HISTORIC AND DESIGN REVIEW COMMISSION

May 15, 2019

HDRC CASE NO: 2019-229
ADDRESS: 518 BURNET ST
LEGAL DESCRIPTION: NCB 546 BLK 19 LOT N 183 FT OF 5
ZONING: R-6, H
CITY COUNCIL DIST.: 2
DISTRICT: Dignowity Hill Historic District
APPLICANT: Morgan Villegas/VILLEGAS ALEJANDRO & VILLEGAS MORGAN
OWNER: Morgan Villegas/VILLEGAS ALEJANDRO & VILLEGAS MORGAN
TYPE OF WORK: Porch railings
APPLICATION RECEIVED: April 17, 2019
60-DAY REVIEW: June 16, 2019
CASE MANAGER: Edward Hall

The applicant is requesting a Certificate of Appropriateness for approval to install wood, front porch railings and replace the existing, non-original porch railings on the historic structure at 518 Burnet.

OHP RECOMMENDED DETAIL

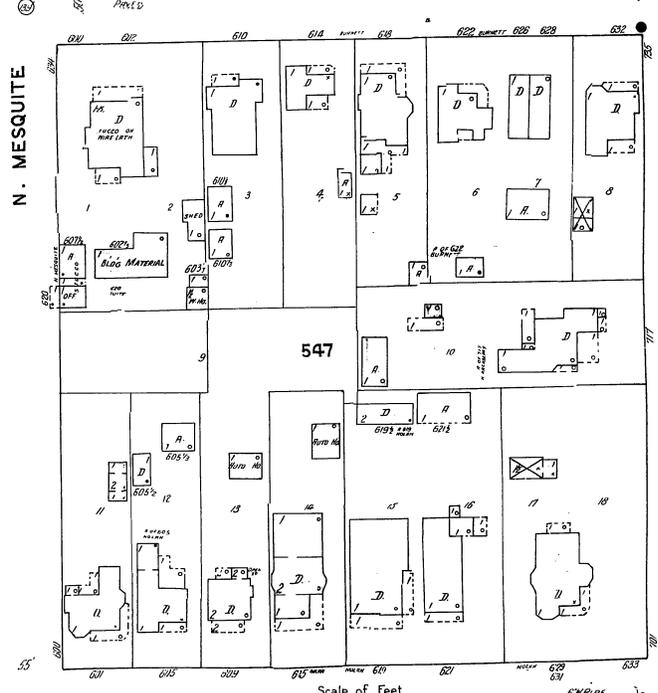
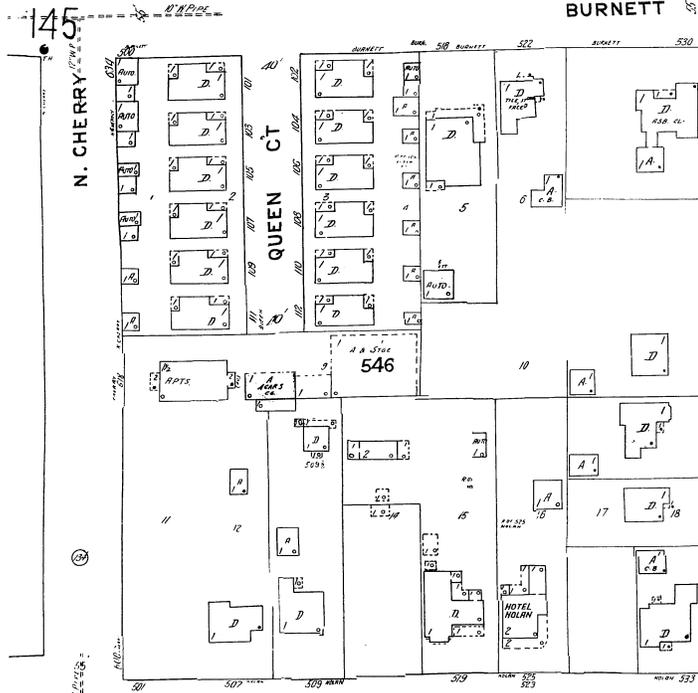
- b. **PORCH RAILINGS** – The applicant has proposed to install porch railings that are to feature wood elements, as well as replace the existing, non-original metal stair railings. Staff finds the installation of porch railings to be appropriate; however, staff finds that the porch railings should be simple in design as to not appear original. The proposed railings should feature both a top and bottom rail. The bottom rail should feature a vertical orientation and should be installed approximately three to four inches above the porch decking. Both top and bottom rails should be constructed from 2"x4" members. The proposed railing should not feature an overall height of more than three (3) feet.

- i. That the porch and stair railings be simple in design as to not appear original. The proposed railings should feature both a top and bottom rail. The bottom rail should feature a vertical orientation and should be installed approximately three to four inches above the porch decking. Both top and bottom rails should be constructed from 2"x4" members. The proposed railing should not feature an overall height of more than three (3) feet.
